REFERENCE:	Nova Bus Manuals
SECTION:	12: Access Ramp
RS N°:	MQR 7621-1618
EFFECTIVE IN PROD.:	LC55 (2019SE)

SUBJECT:	Hydraulic Power Unit of the Access Ramp
JUSTIFICATION:	The plastic reservoir of the HPU can crack and leak. A leakage could lead to a malfunction of the access ramp.

CALMO RETROFIT PROCEDURES	Doc #: Retrofit-Houston
	Aluminium Reservoir(HPU) Retrofit	PAGE : 1 / 27
	ASSEMBLY (P/N 8060-07-A2)	SUBJECT : Alum Reservoir Retrofit

Figure 4 - Drill two new Holes

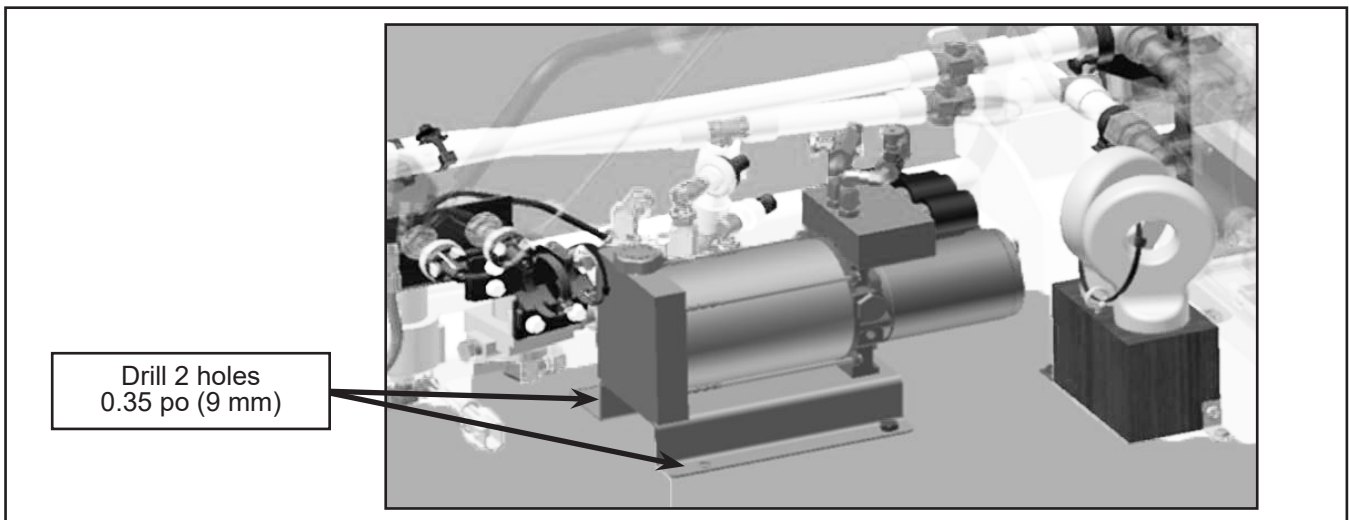
- 1.10. Inside the vehicle, position the HPU as shown in Figure 4.
- 1.11. Insert the two removed screws in existing holes. Use the HPU support as jig to mark the two other holes. Remove HPU.
- 1.12. Drill two holes of 0.35 po (9 mm) through the floor.

- 1.13. Reinstall the HPU. Insert the two removed screws and two new ones (N16757).
- 1.14. Under the vehicle, install onto the four screws, four flat washers (the two removed ones at removal and two new ones (N21101)) and four new nylon lock nuts (N10859). Tighten.
